**SECTION 4.55(2) MODIFICATION OF DEVELOPMENT CONSENT**

**ADDRESS:** 23-29 HARVEY AVENUE, MOOREBANK, 2170  
LOT 28, DP 236405  
**DESCRIPTION:** Modification to development consent DA-6/2018 under Section 4.55(2) of the Environmental Planning and Assessment Act 1979, for internal and external alterations and additions.

Reference is made to modification application DA-627/2018/A which seeks amendment to development consent DA-627/2018 issued for:

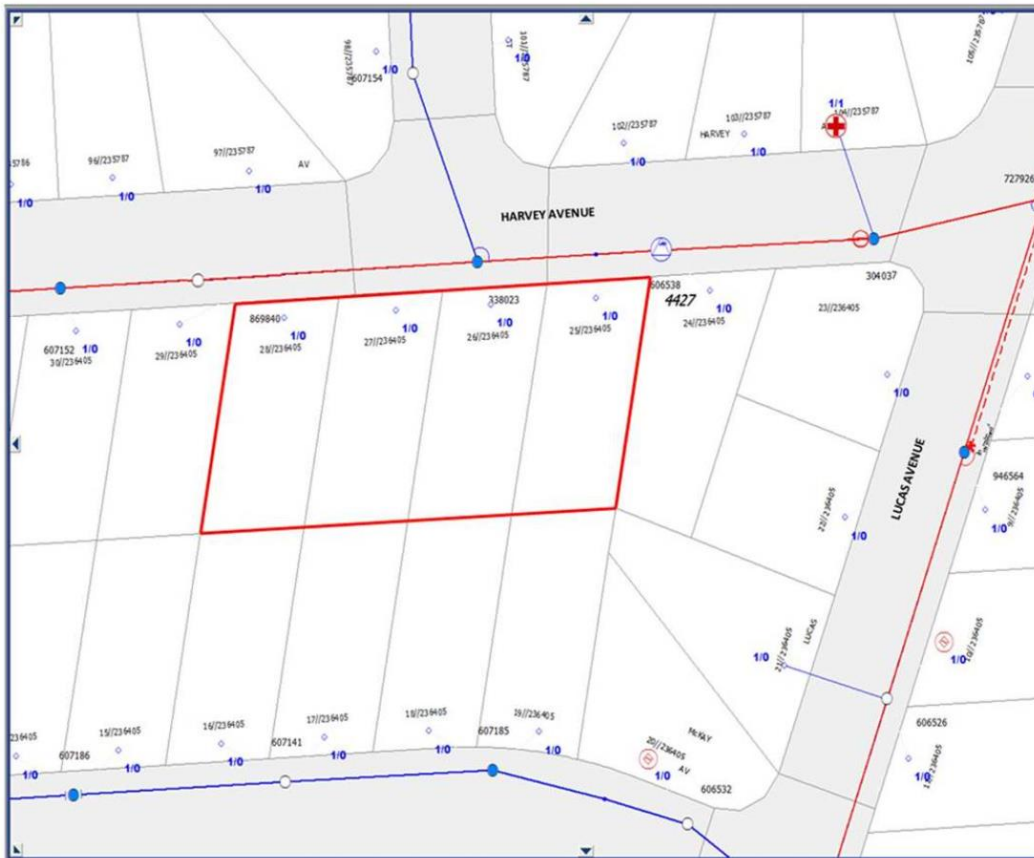
Endeavour Energy has noted that as shown in the following extract of the Landscape Plan the planting of trees is proposed to the front building setback in proximity of the existing electricity infrastructure to the road verge / roadway. Endeavour Energy's recommendation is that trees in proximity of electricity infrastructure be replaced with an alternative smaller planting to ensure appropriate clearances are maintained whilst minimising the need for future pruning. Consideration also needs to be given to the new service conductor/ customer connection point required to facilitate the proposed development of the site.

#### A4.3 - Padmount easements and clearances

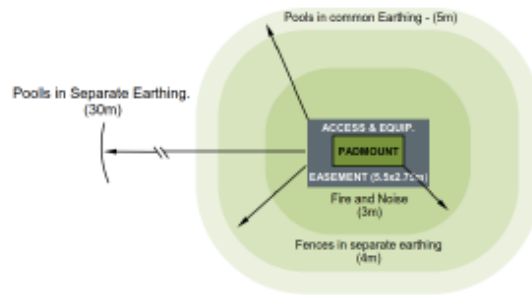
As shown in the following extract of Endeavour Energy's Mains Design Instruction MDI 0044 'Easements and Property Tenure Rights', Figure A4.3 'Padmount easements and clearances', padmount substations require:

- Easement with a minimum size of 2.75 x 5.5 metres (single transformer).
- Restriction for fire rating which usually extends 3 metres horizontally from the base of the substation footing / plinth.
- Restriction for swimming pool or spa which extends 5 metres from the easement.

Generally it is the Level 3 Accredited Service Provider's (ASP) responsibility (engaged by the developer) to make sure padmount substation location and design complies with Endeavour Energy's standards the suitability of access, safety clearances, fire ratings, flooding etc.

As a condition of the Development Application consent Council should request the submission of documentary evidence from Endeavour Energy confirming that satisfactory arrangements have been made for the connection of electricity and the design requirements for the substation, prior to the release of the Construction or Subdivision Certificate / commencement of works.

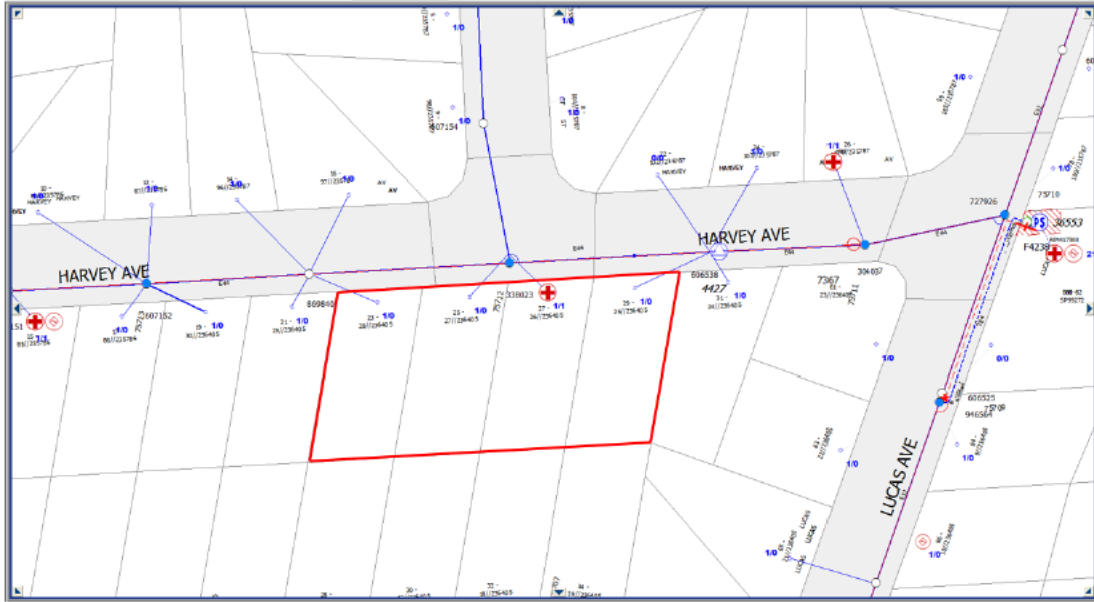
The Section 4.55 (2) Modification Report indicates the modifications include 'Provide a substation at the northeast corner of the site' which is shown in the following extracts of the Architectural Plans.
